Exhibit # 4

The SSBXL20-10MED Block diagram.

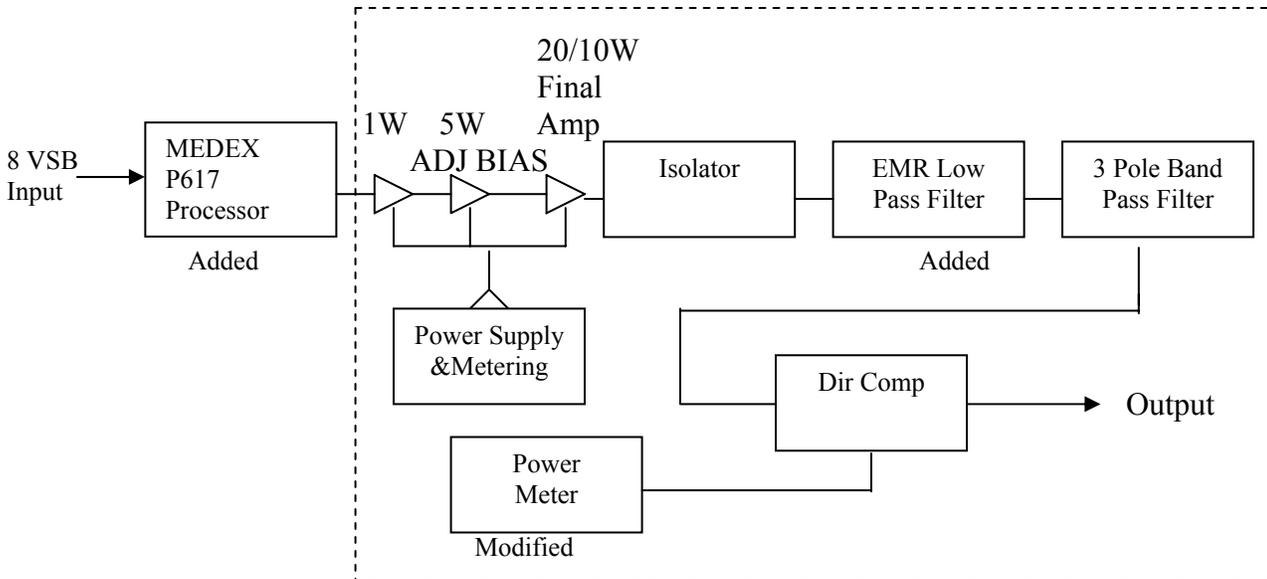
No parts were changed except in the power metering circuit. Only the amplifier bias was adjusted for the least distortion and best linearity. The EMR low pass filter was the only component added. The MEDEX P617 processor downconverts the 8VSB signal to IF and upconverts it to the desired UHF channel.

Everything within the dotted line is contained within the cabinet of the existing unit already type certified.
